Service Bulletin

Bulletin No.: 24-NA-156

Subject: Information on Dealer Installed Accessory Trailer Hitch Installation Concern

Brand:	Model:	Model Year:		Build Date Breakpoint:		Engine:	Transmission :
		from	to	from	to		
Chevrolet	Equinox EV	2024	2024	SOP	July 30, 2024	All	All

6692657

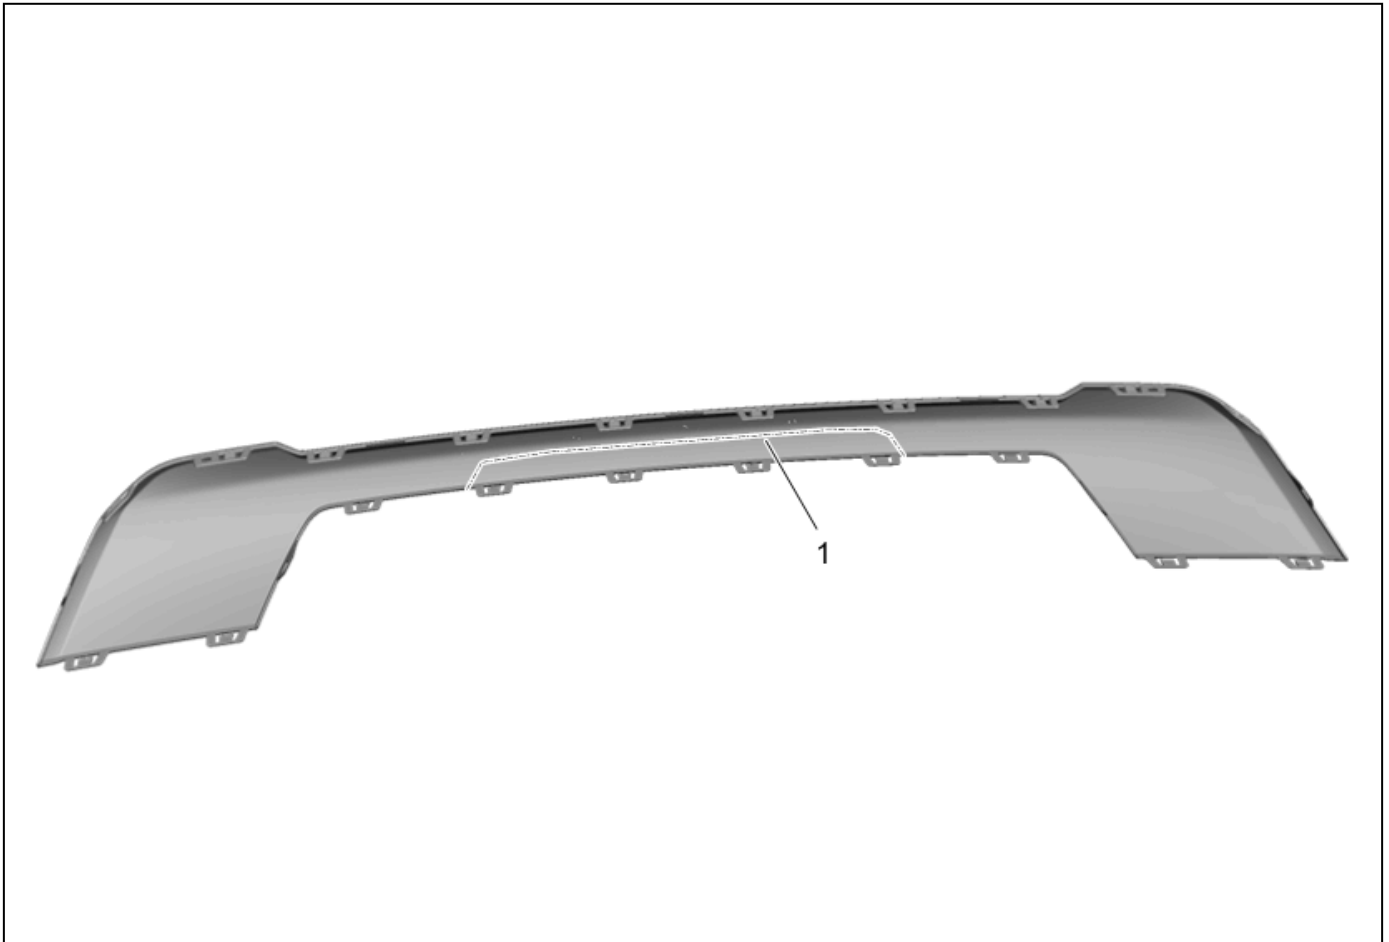
During Installation, on the inside of the rear fascia skid plate, check to see if there is a scribed line (1) present in the location shown. If no scribed line is present, then a new rear fascia skid plate P/N 85629520 must be ordered before proceeding to the next step.

Dealers will be directed to contact the supplier for P/N 85629520, which will have the scribe lines present. The supplier will send them to dealers free of charge. Please contact Carlos Ortiz at +52-844- 318-7613 or email at carlos.ortiz@opmobility.com.
